PLANNING AND INSPECTIONS DEPARTMENT

TO: Pinehurst Historic Preservation Commission
FROM: Alex Cameron, Senior Planner
DATE: 7/18/2019
SUBJECT: Staff Approvals of Minor Work

STAFF APPROVALS REPORT for LOCAL HISTORIC DISTRICT
July 25, 2019 MEETING
06/16/19 TO 07/15/19

**HISTORIC PRESERVATION COMMISSION
REGULAR MEETING MINUTES
JUNE 27, 2019
ASSEMBLY HALL
395 MAGNOLIA RD.
PINEHURST, NORTH CAROLINA
4:00 PM**

L-101

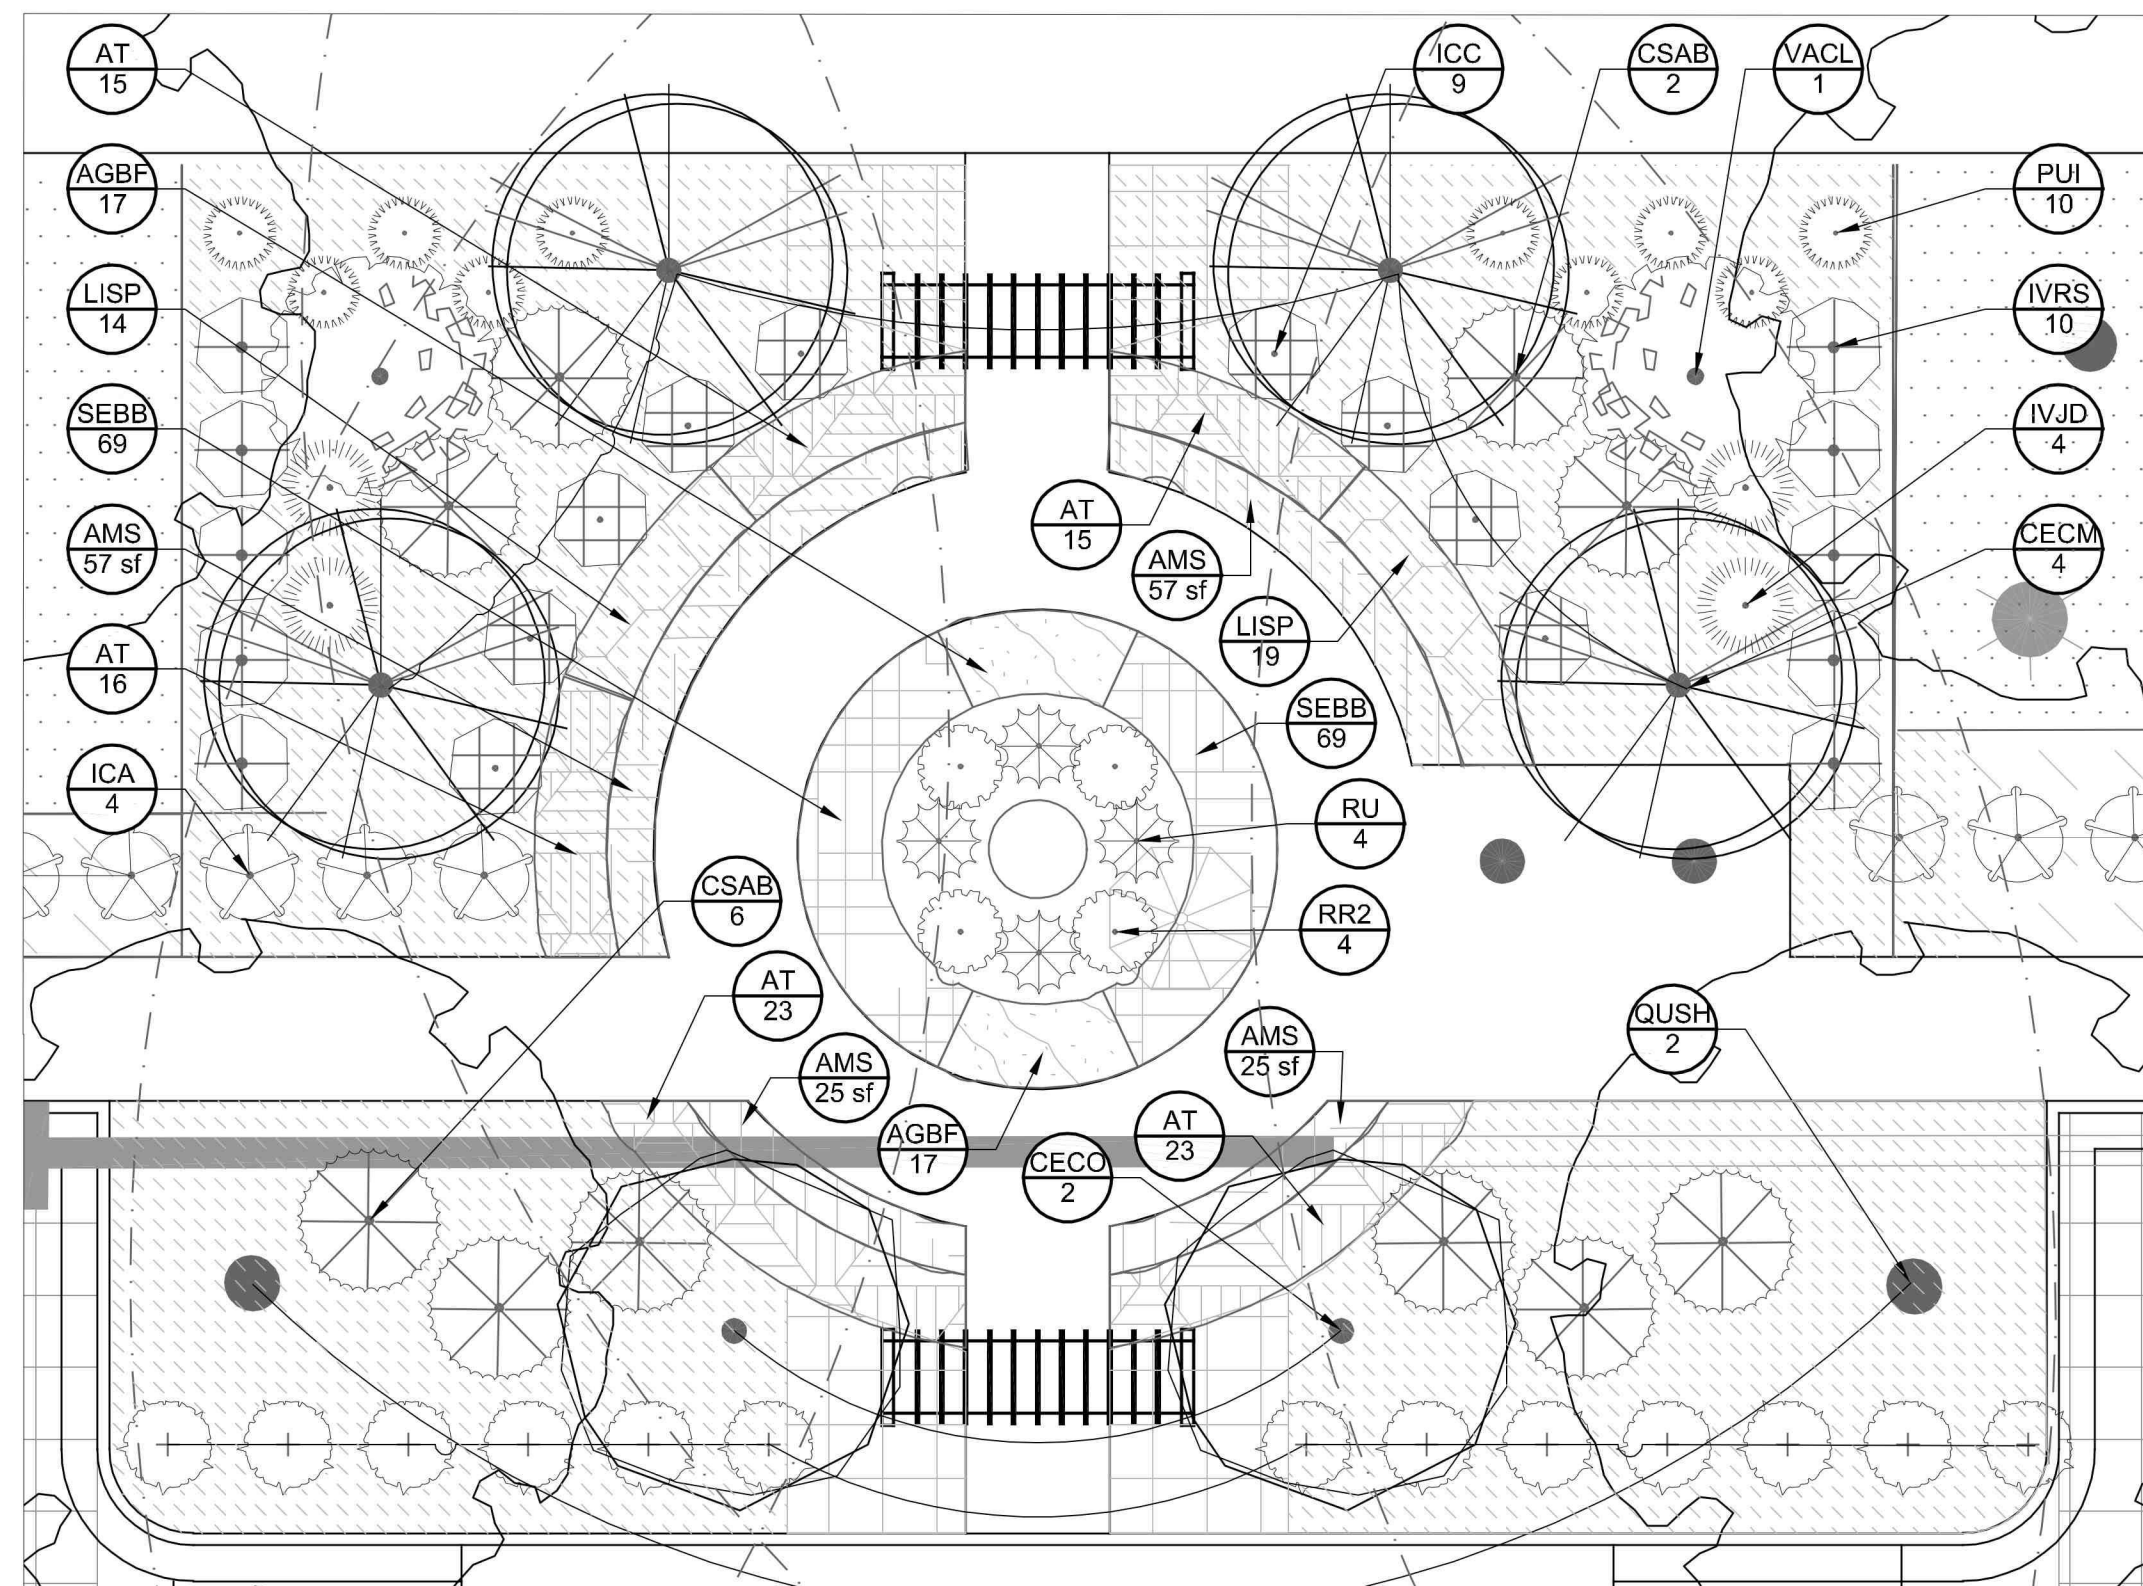
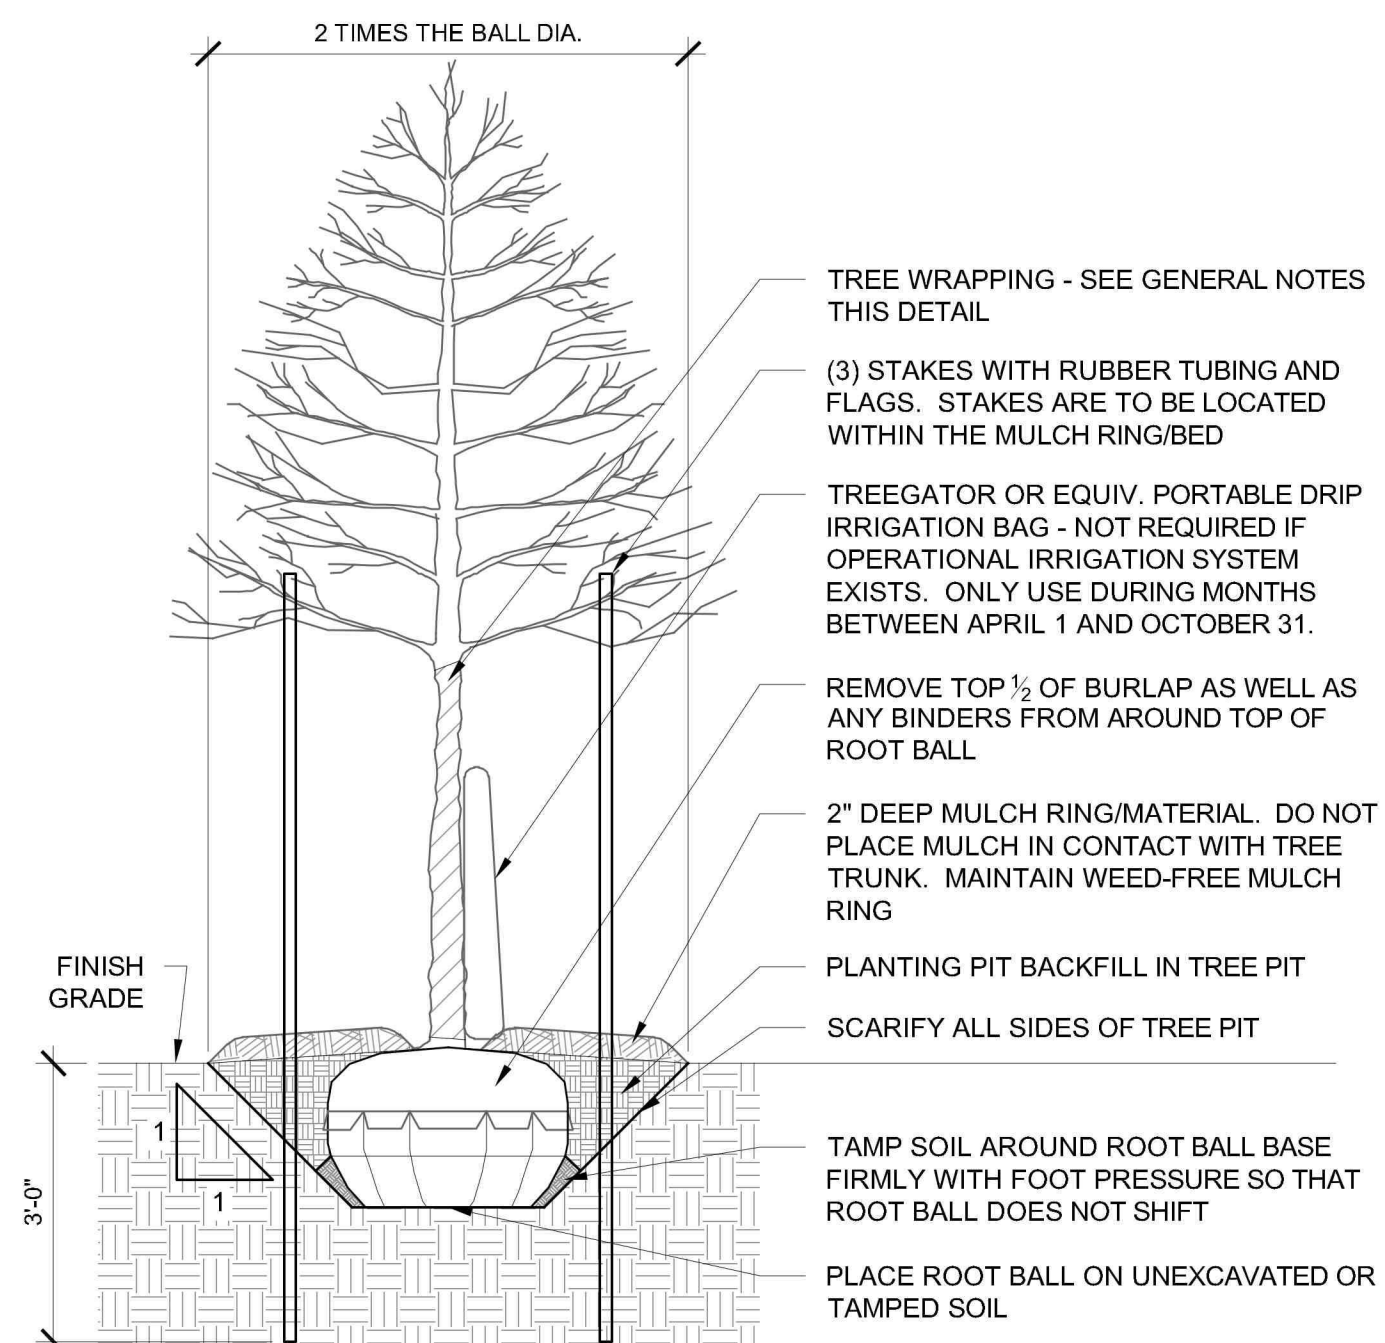
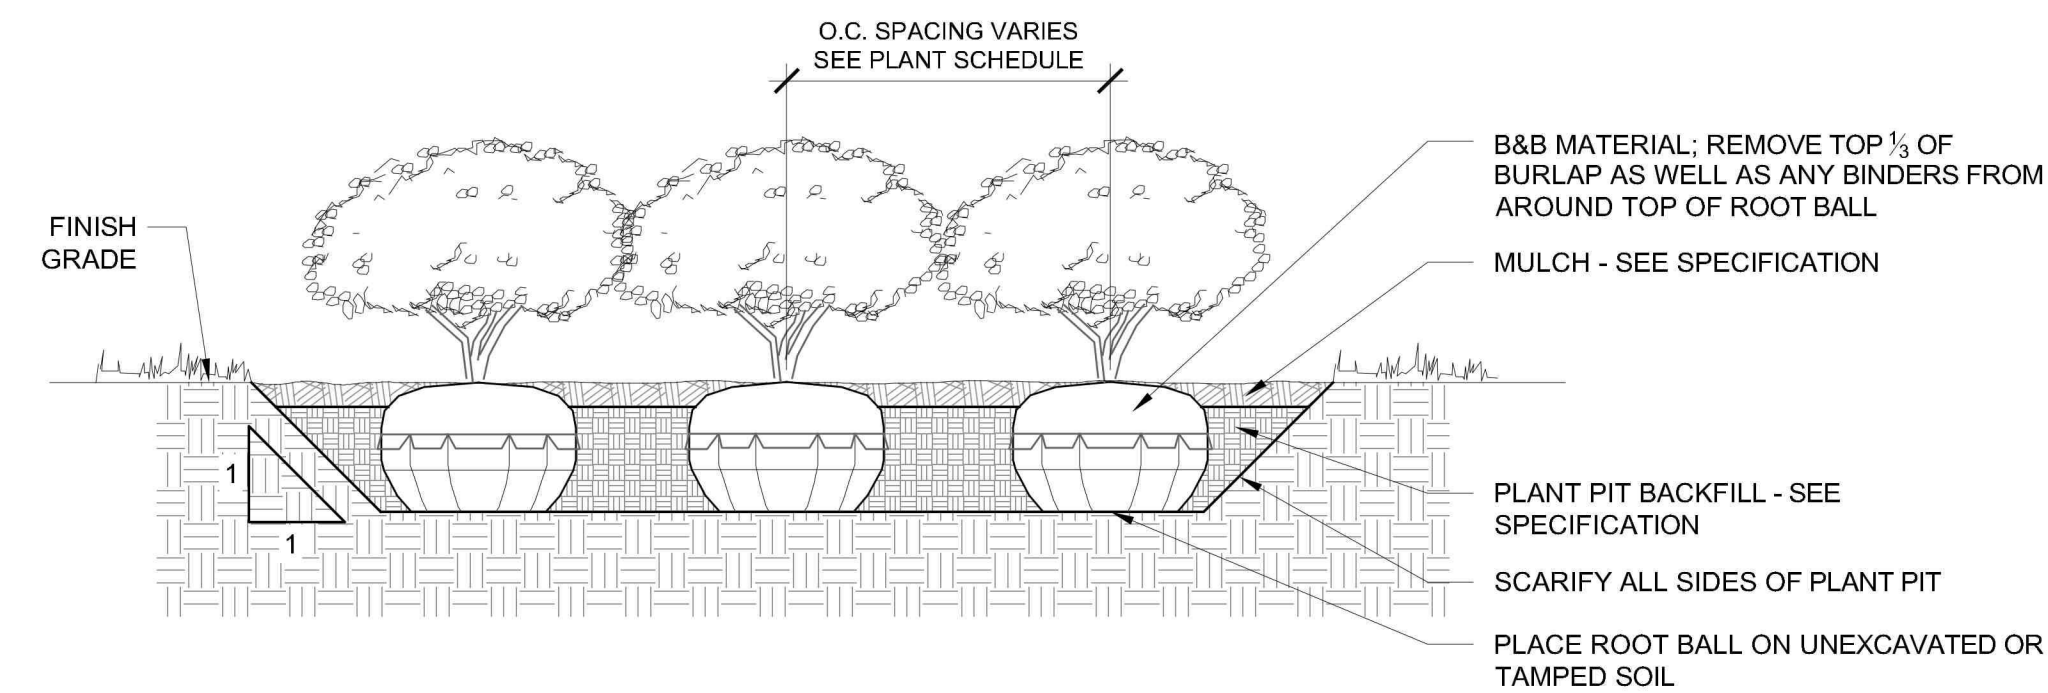
1. Substantial mass grading will need to occur within the development envelope to remove existing buildings and install new buildings, play areas, walkways, stormwater treatment, sidewalks, drive aisles, and parking.
2. Site detail sheet C-200 depicts removal of trees and also shows tree protection areas and fencing to trees to be preserved along the site perimeter.
3. Site Detail Sheets L-100 and L-101 depict the extensive types, sizes and location of vegetation to be planted.

1. *Additions or alterations to the existing landscape, including plant material, hardscape, and accessory structures, **must** be compatible with the architectural character of the primary structure and congruous with the Pinehurst Historic District.* The applicant proposes extensive replanting to supplement trees to be preserved. Plantings include species typical to the area and incorporates deciduous and evergreen species – including native species – ornamentals, and grasses. The species vary in height and placement from ground cover to understory and canopy.

2. *Removal of trees twelve (12) inches in diameter at breast height (DBH) and larger **must not** unreasonably compromise the existing tree canopy and the historic appearance of the landscape.* Based on the size of the site and extent of site modification to accommodate a new school, the existing canopy will be impacted. The applicant has compensated with supplemental plantings along the perimeter, island trees in the parking lot, shrubs and ornamentals along the walkways and buildings and foundation plantings.

Proposed
garage

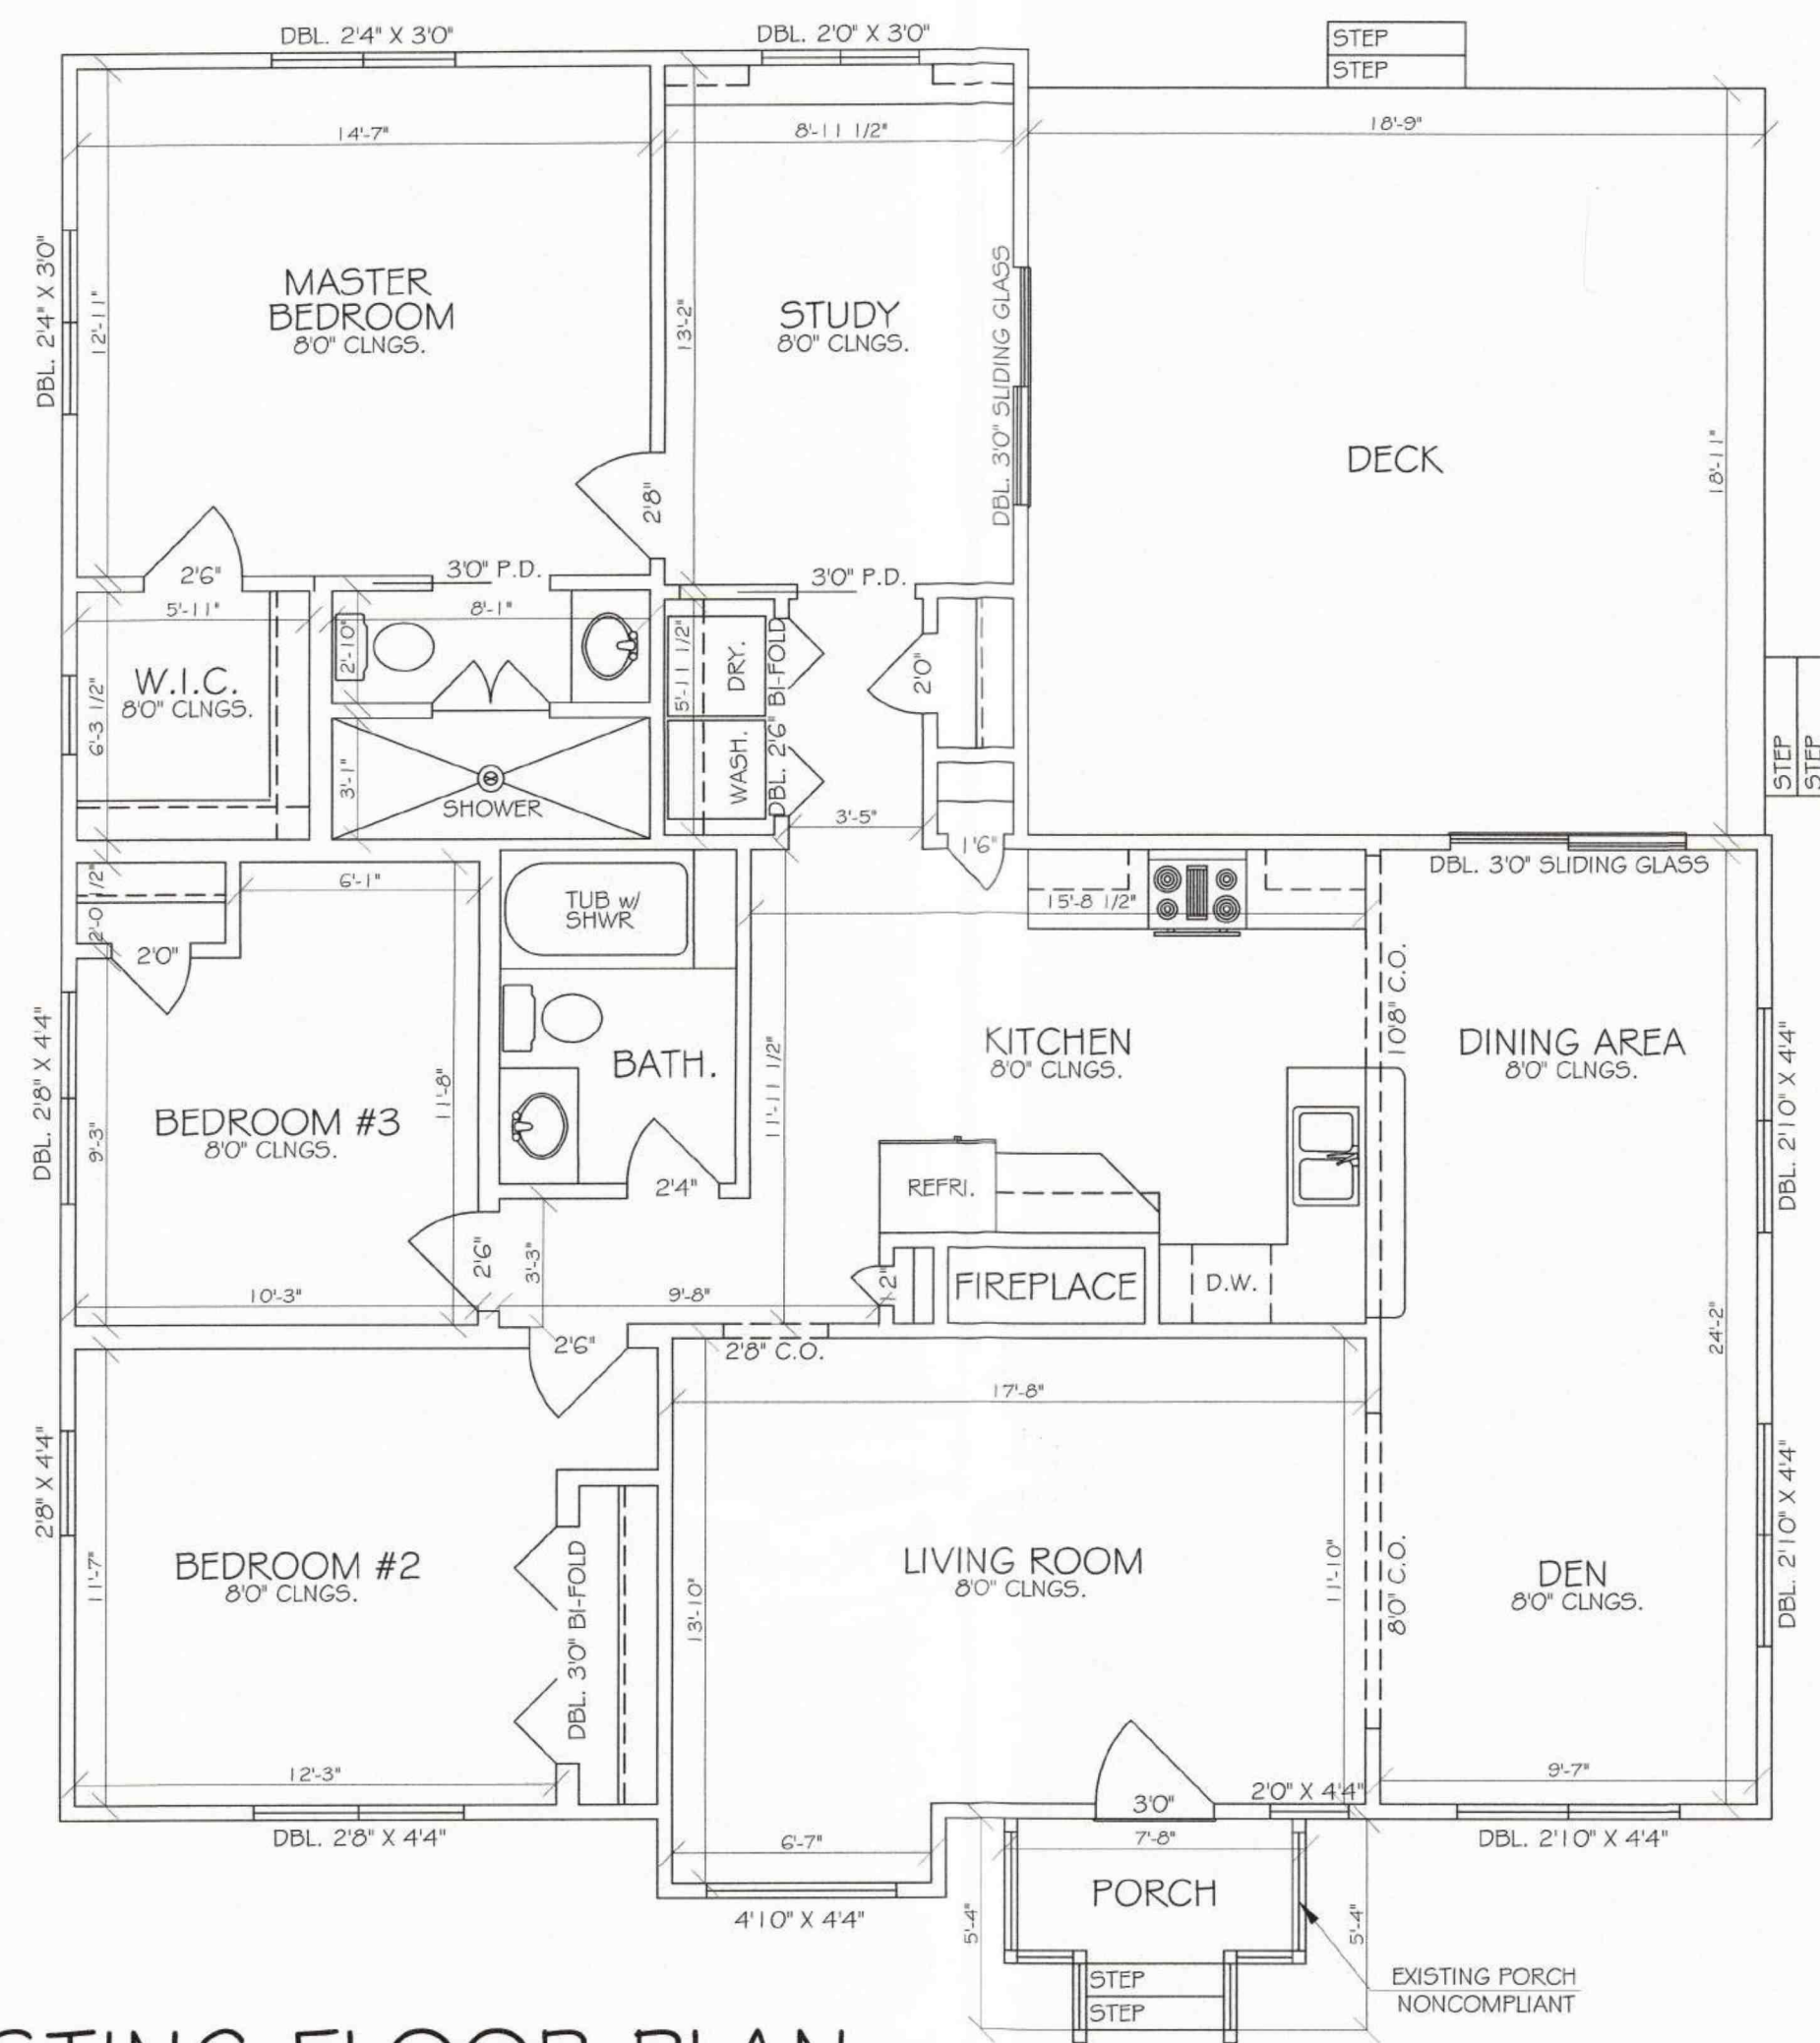
The following conditions apply to approval of the Certificate of Appropriateness for 310 Dundee Road.
